December 8th, 2017

SUBJECT: Friendship Village
 MnDOT Review P17-031A
 SE quad US169 and I-494
 Bloomington, Hennepin County
 Control Section 2776

March 29th, 2018

SUBJECT: Friendship Village
 MnDOT Review P17-031B
 SE quad US169 and I-494
 Bloomington, Hennepin County
 Control Section 2776

PROTECTION AND RESTORATION OF VEGETATION

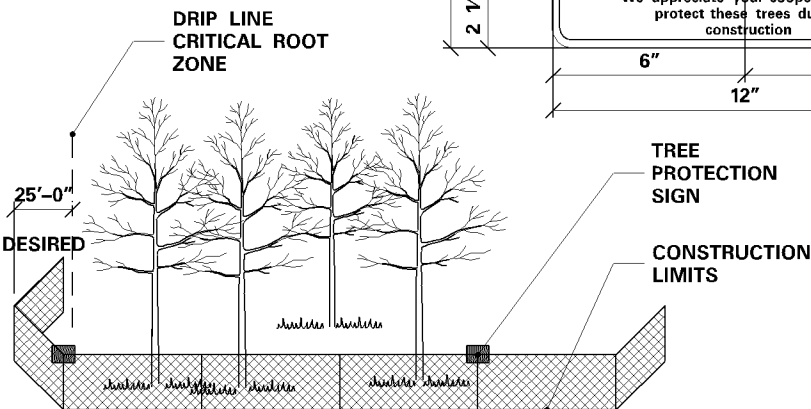
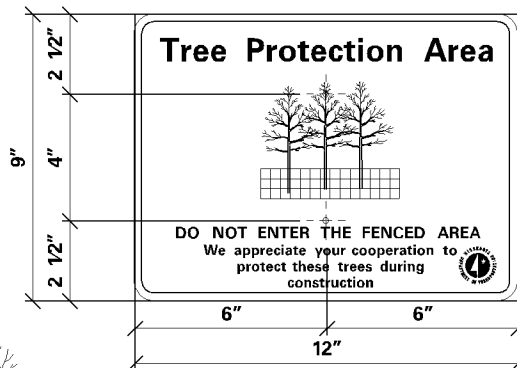
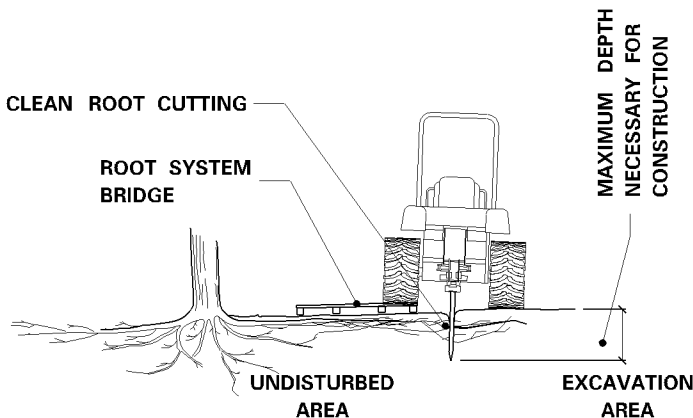
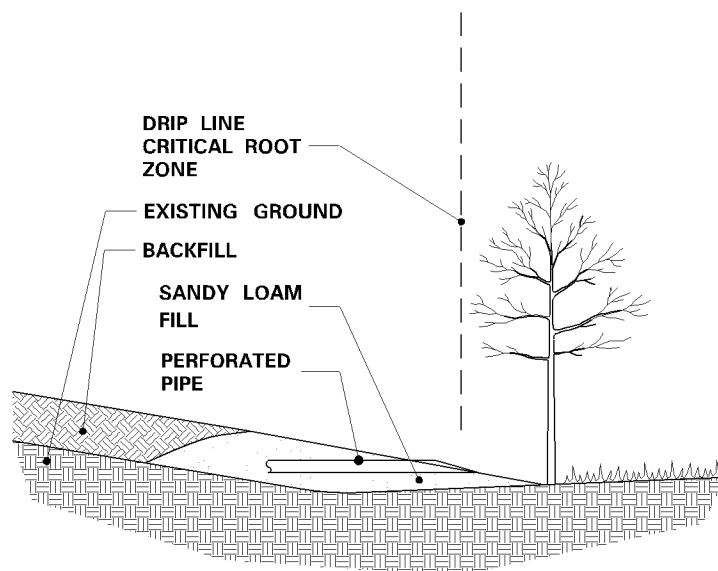
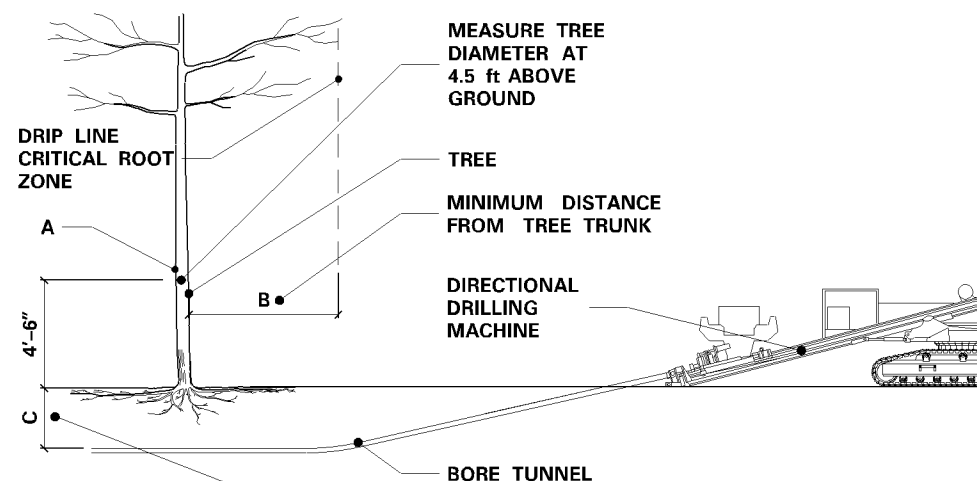
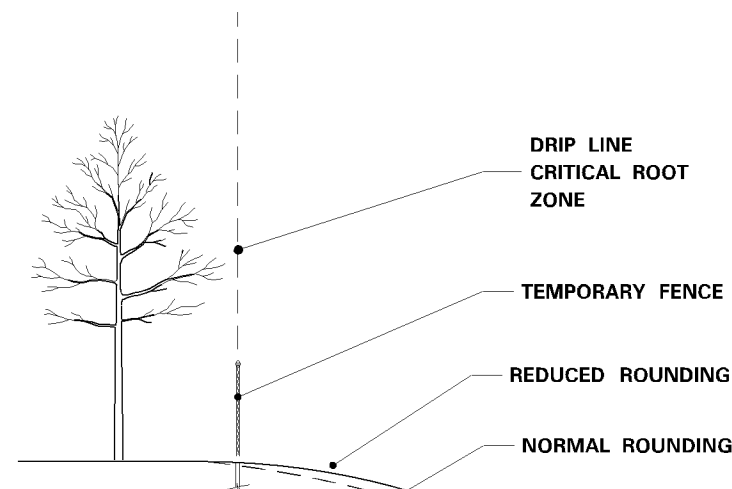
The trees on MnDOT right-of-way will need to be protected during construction. The protection around the tree will need to be to the drip line, even if that is on private property. Please reference the attached sheet for details on tree protection.
